Urgent Field Safety Notice

Subject: Liko® Viking® L, Viking® M, Viking® XL , and Viking® 300 Mobile Lifts – Potential Actuator Damage

FSCA-identifier: Mod 1228

Type of action: Corrective Action Notification

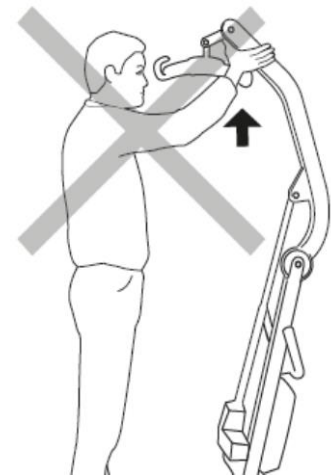
This issue is preceded by users who lift the lift arm assembly manually, as shown in the illustration to the right.

The lift arm assembly is intended to only be lifted by the actuator (lift motor). If the lift arm assembly is manually lifted, the actuator can become damaged and get stuck in the highest position. When the actuator is stuck, the lift cannot be raised/lowered by the lift motor. If a patient is lifted into the sling while the actuator is stuck, there is a potential risk of a free fall of the patient. This hazard could cause minor or potentially catastrophic injuries to a patient if the free fall encompasses the entire stroke of the actuator.

Hill-Rom is sending a customer notification requesting customers not to raise the lift arm manually since the lifting actuator can become stuck and/or become damaged. Customers will be instructed to always use the hand controls or the control box to operate the lift. There are no hazards when using the device as intended. Hill-Rom is updating the product labelling to address this hazard with the attached customer notification we expect you to forward to your customers.

Hill-Rom is concerned that the actuator may have become damaged from manually lifting, therefore, is more susceptible to becoming stuck in the highest position if manually lifted again. To reduce the risk of this occurring, Hill-Rom is announcing a correction that will include an inspection of all potentially affected Viking® lifts. If there is damage to the actuator, it will be replaced.

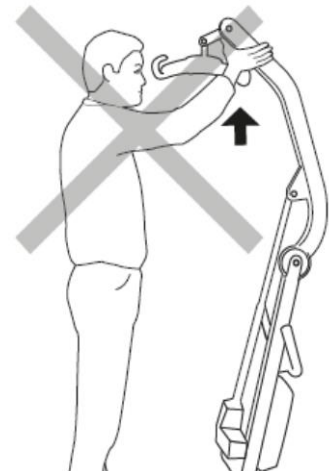
This issue is preceded by users who lift the lift arm assembly manually, as shown in the illustration to the right.

The lift arm assembly is intended to only be lifted by the actuator (lift motor). If the lift arm assembly is manually lifted, the actuator can become damaged and get stuck in the highest position. When the actuator is stuck, the lift cannot be raised/lowered by the lift motor. If a patient is lifted into the sling while the actuator is stuck, there is a potential risk of a free fall of the patient. This hazard could cause minor or potentially catastrophic injuries to a patient if the free fall encompasses the entire stroke of the actuator.

Hill-Rom requests customers not to raise the lift arm manually since the lifting actuator can become stuck and/or become damaged. Always use the hand controls or the control box to operate the lift. There are no hazards when using the device as intended. Hill-Rom is updating the product labelling to address this hazard.

Hill-Rom is concerned that the actuator may have become damaged from manually lifting, therefore, is more susceptible to becoming stuck in the highest position if manually lifted again. To reduce the risk of this occurring, Hill-Rom is announcing a correction that will include an inspection of all potentially affected Viking® lifts. If there is damage to the actuator, it will be replaced.
